**Figure 2.1 from MRP-227**

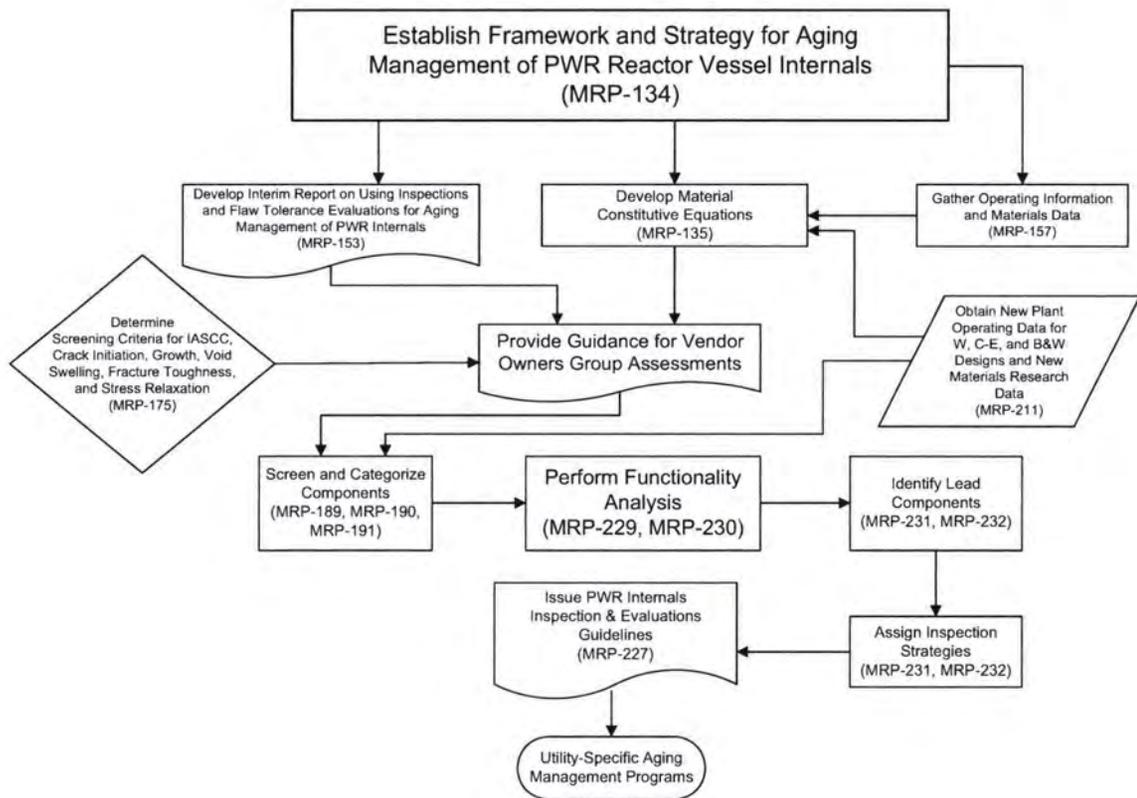
**RAI 3-2** TR MRP-227, Rev. 0, does not make reference to Nuclear Energy Institute (NEI) Report No. NEI 95-10, Revision 6,<sup>2</sup> 2 as an applicable industry license renewal report; nor does TR MRP-227, Rev. 0, provide any discussion on how it will be used to conform to the recommendations in NEI 95-10, Rev. 6, when implementation of the I&E recommendations are applied as license renewal activities and methods for aging management of RVI components. Discuss how and provide the basis for why the recommended I&E scoping/screening process, inspection activities, evaluation methods and acceptance criteria in TR MRP-227, Rev. 0, are considered to be in conformance with the recommendations in NEI 95-10, Rev. 6, paying particular attention to conformance with Chapters 2, 3, and 4 of the NEI 95-10, Rev. 6, and the license renewal processes identified therein for implementation in Figures 2.0-1, 3.0-1, 4.1-1, 4.2-1, and 4.3-2.

The overall license renewal process is outlined in Figure 2.0-1. There are two major branches in Figure 2.0-1. The first branch describes aging management activities including the development of AMRs and associated AMPs. The second branch describes the process used for Time Limited Aging Analysis (TLAA). MRP-227, Revision 0 and its supporting documents provide the technical basis for aging management of systems structures and components within the reactor internals. This objective of the MRP effort was to provide documents that would support utilities in the implementation process and allow appropriate revisions to the NUREG-1801, Revision 1 (GALL) report. While MRP-227, Revision 0 is not intended to follow the implementation process precisely, it is certainly supports the aging management branch of the license renewal process. Its recommendations are consistent with the intent of the process and assure utility conformance in the license renewal process.

The method used to identify systems, structures and components within the scope of the license renewal rule is described in Section 3 of NEI 95-10 and outlined in Figure 3.0-1. Note that the process described in Figure 3.0-1 does not distinguish between systems, structures and components. The footnote to the rule in the Federal Register contains the following clarification:

Figure 4.1-1 describes the NEI 95-10 process for identifying specific structures and components and their function. Both the SRP-LR (NUREG-1800, Revision 1) and the GALL Report (NUREG-1801, Revision 1) identify the reactor internals as part of the Reactor Vessel, Internals and Reactor Coolant system. The reactor internals include several recognized structures (e.g., core barrel assembly, control rod guide tubes). However, the MRP analysis was completed on a component by component basis. The functions of the components and their relevance to the function of the reactor internals as a whole are described in MRP-189, Revision 1 and MRP-191. Table 2.1-5 of NUREG-1800, Revision 1 identifies the reactor internals as a "Structure, Component or Commodity that meets the Requirements of 10CFR54.21(a)(1)(i)". The reactor internals components are all passive and are not replaced on a regular basis and are, therefore, by the criteria of 10CFR54.21(a)(1)(i) and (ii), subject to management review. The NEI 95-10 process suggests that commodity groupings may be applied to the items requiring management review. The structure of the MRP review does contain several examples of large groupings of components. For instance the baffle bolting is listed as a single component item. In practice there may be hundreds of baffle bolts and there may be large variations in the stresses and irradiation exposure of the individual bolts. Similar variations may exist for reactor internals structures such as the lower support columns or the control rod guide tube assemblies. The structure of the analysis should be evident in MRP-189, Revision 1 and MRP-191.

A large portion of the MRP effort has been devoted to identification of those aging effects that require management. The MRP process was consistent with the upper portion of Figure 4.2-1 from NEI 95-10. The screening and FMECA processes described in the response to RAI 3-1 are consistent with the NEI 95-10 process. Tables 3.1, 3.2 and 3.3 of MRP-227 identify the relevant aging effects for the reactor internals.

The process used by the utility to evaluate available AMPs is described in Figure 4.3-2. The intent of the MRP effort was to define AMP options for the anticipated revision of NUREG-1801, Revision 1. Section 4.3.2 outlines the general requirements for a Plant
